Model: G-P3	Date: 12-Mar-08	No.: RG190001e
-------------	-----------------	----------------

Subject: Firmware Release Note: Engine		Prepared by: Y. Suzuki	
From: 3rd Tech Service Sect., MFP/Printer Tech Service Dept.			
Classification:	<input type="checkbox"/> Troubleshooting	<input type="checkbox"/> Part information	<input type="checkbox"/> Action required
	<input type="checkbox"/> Mechanical	<input type="checkbox"/> Electrical	<input type="checkbox"/> Service manual revision
	<input type="checkbox"/> Paper path	<input type="checkbox"/> Transmit/receive	<input type="checkbox"/> Retrofit information
	<input checked="" type="checkbox"/> Other ()

This RTB has been issued to announce the firmware release information for the **Engine**.

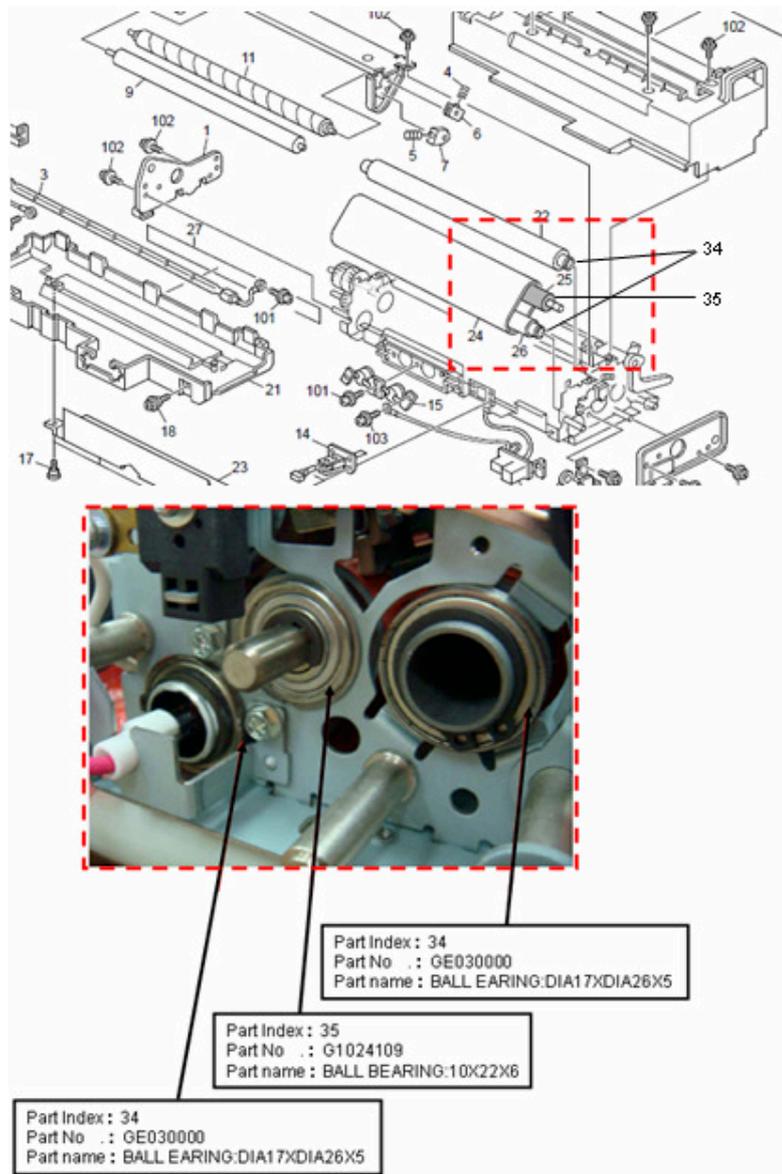
Old part number	New part number	Description	Q'ty	Int	Page	Index	Note
	GE030000	BALL EARING:DIA17XDIA26X5	0 - 1		24	34*	
	G1024109	BALL BEARING:10X22X6	0 - 1		24	35*

Change/Reason: These parts were missing from the Parts Catalog.

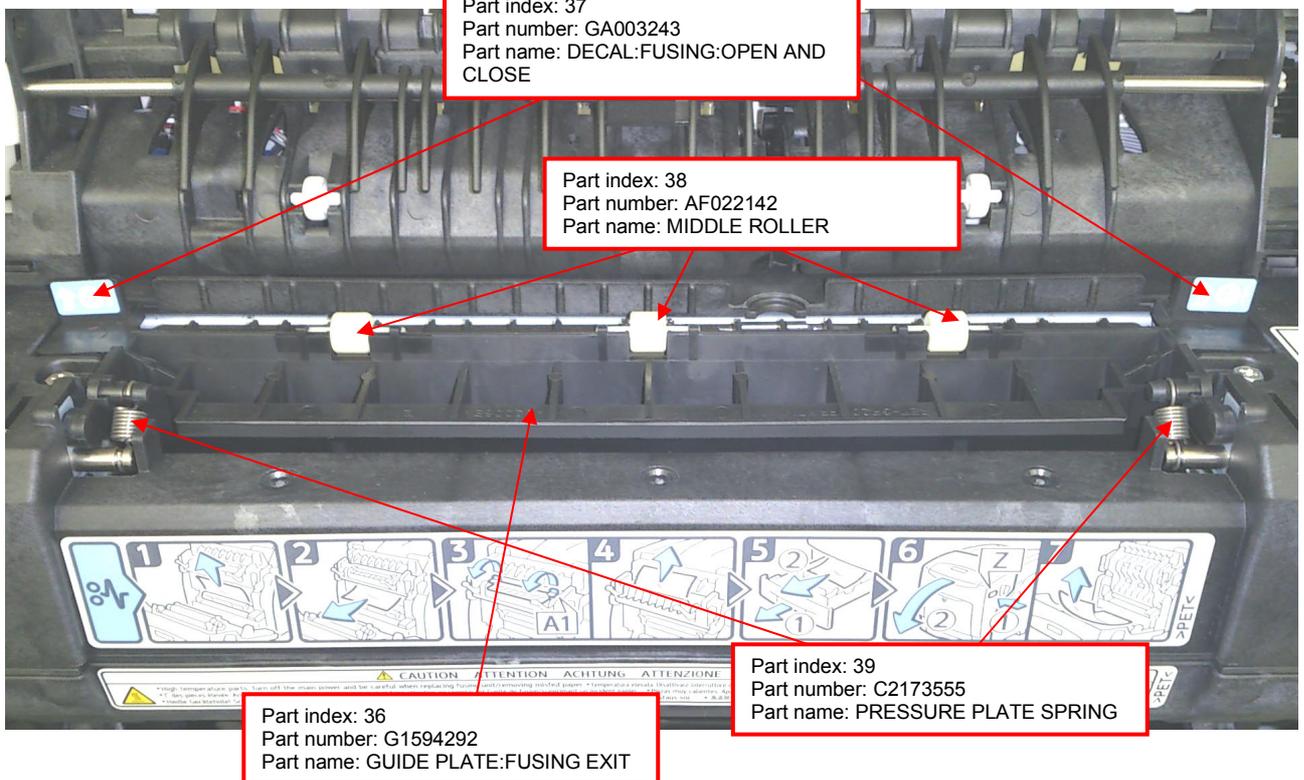
Old part number	New part number	Description	Q'ty	Int	Page	Index	Note
	G1594292	GUIDE PLATE:FUSING EXIT	0 - 1		24	36*	Add
	GA003243	DECAL:FUSING:OPEN AND CLOSE	0 - 2		24	37*	Add
	AF022142	MIDDLE ROLLER	0 - 3		24	38*	Add
	C2173555	PRESSURE PLATE SPRING	0 - 2		24	39*	Add

Change/Reason: These parts were missing from the Parts Catalog.

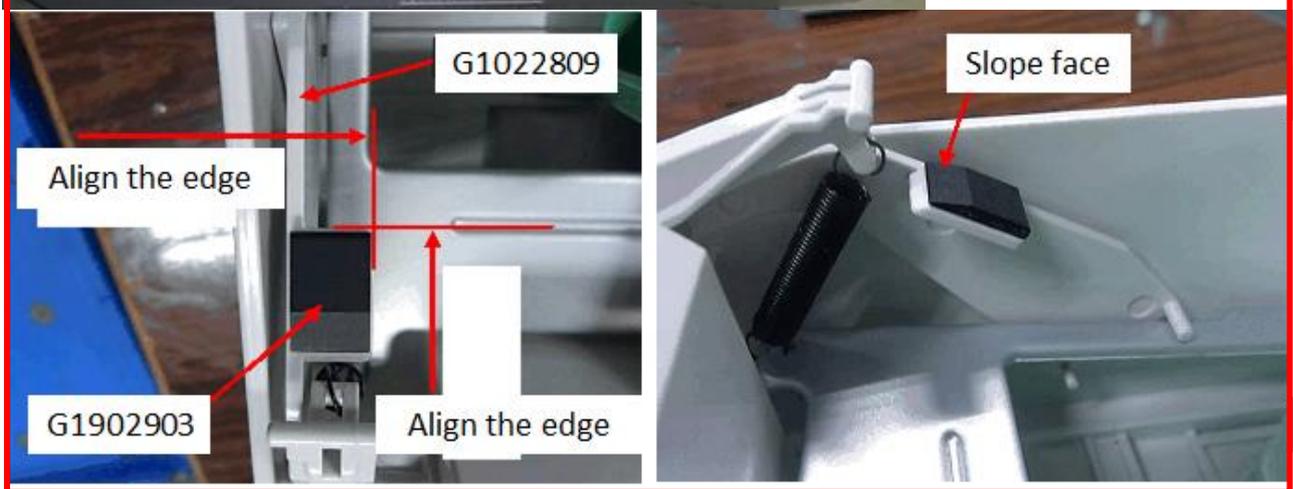
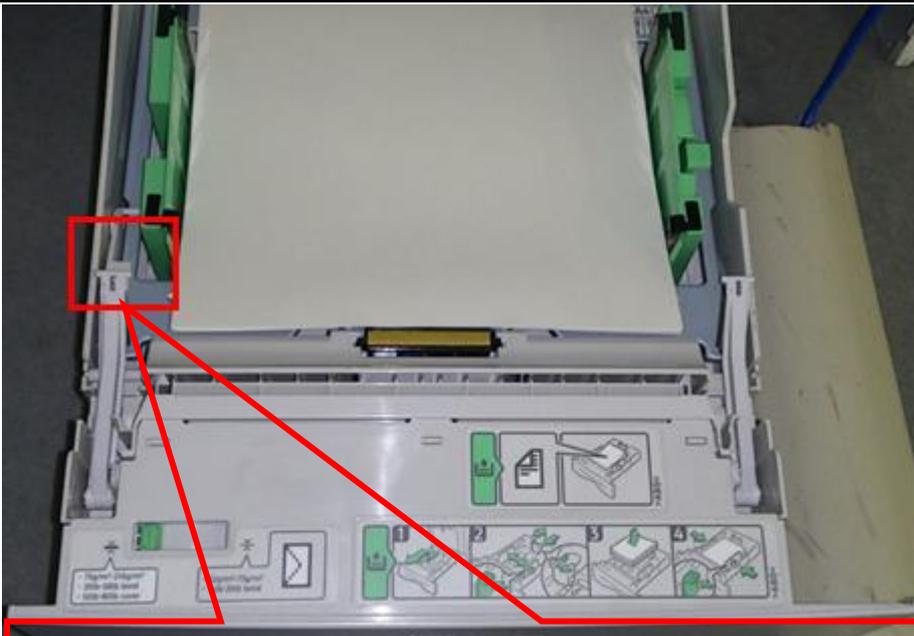
The icon for 11-30% paper remaining in the tray (≡) does not change even when the actual amount of paper remaining reaches 1-10%.

Tolerance stack-up (cumulative effect of parts tolerance)

Add a spacer (G1902903) to the BASE PAPER VOLUME SENSOR BOARD (G1022809) or install the new part(s) shown below.

Old part number	New part number	Description	Q'ty	Int	Page	Index	Note
G1592527	G1592528	PAPER TRAY:ASS'Y	1 - 1	X/O	7	*	Spacer added
G1022809	G1902904	PAPER VOLUME SENSOR BOARD:BASE:ADHESION	1 - 1	X/O	7	15	Spacer added
	G1902903	SPACER:PAPER VOLUME SENSOR	0 - 1		7		Add

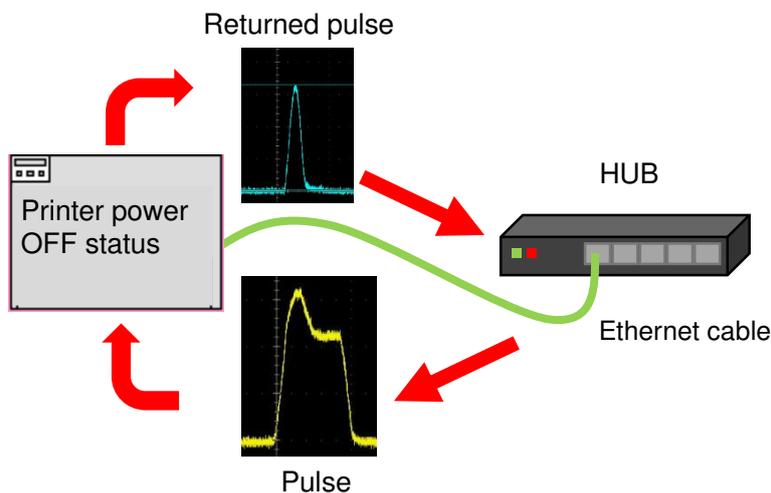
Old part number	New part number	Description	Q'ty	Int	Page	Index	Note
G1905713	G1905714	PCB:CTL:GAIA-P3:EXP:SUB-ASS'Y	1 - 1	X/O	41	4

Interference in network communication may occur if the printer is connected to a hub and the printer switch has been turned OFF (or the power cable was unplugged).

A pulse generated from a hub is transmitted to the printer while the printer is switched OFF (or unplugged). After transmitted to the printer, it then returns to the hub, causing interference in network communication.

A circuit on the Controller Board was modified.
